INITIAL FIRE SAFETY INSPECTION REPORT

Factory Name: Vintage Denim Studio Ltd. (Extended Building)

Date: 2 June 2021

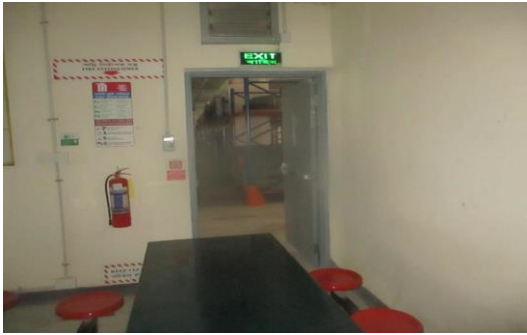
3	Means of Egress	Elevator shafts provided in North stair (stair-A) exit stair enclosure	Modify the elevator and stair enclosure arrangement in a way to satisfy Accord standard 6.14.3. Elevator shall not open into an exit enclosure. Elevator landing door shall be of 1.5-hr fire rated within the factory floor.	Within 4 months
---	-----------------	--	--	-----------------
